Access Compliance Report

Public Rights-of-Way

(Curb Ramps)

Intersection ID: 10034710	Main Street: POINDEXTER_DR	Cross Street: N/A	Location:	N
ADA ID: D91B0F76F79D	Ramp Type: Perp	Initial Pass/Fail: Fail	Overall Compliance: No	Severity Score: 12.5

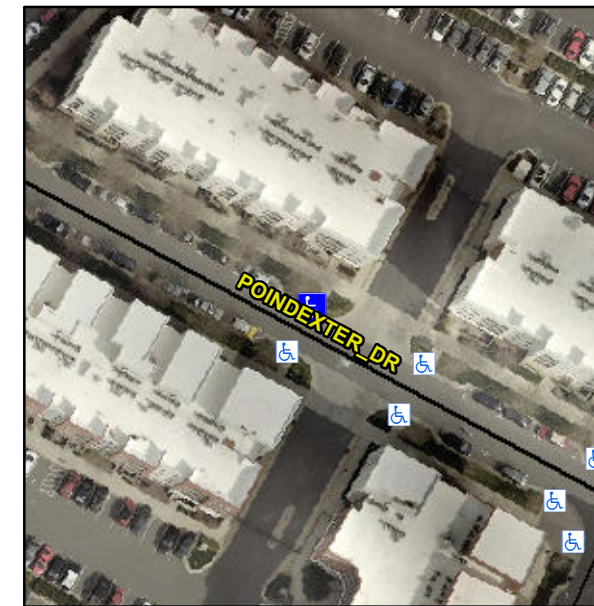
Not Found, R304.2.2

Remove & Replace Entire Ramp.
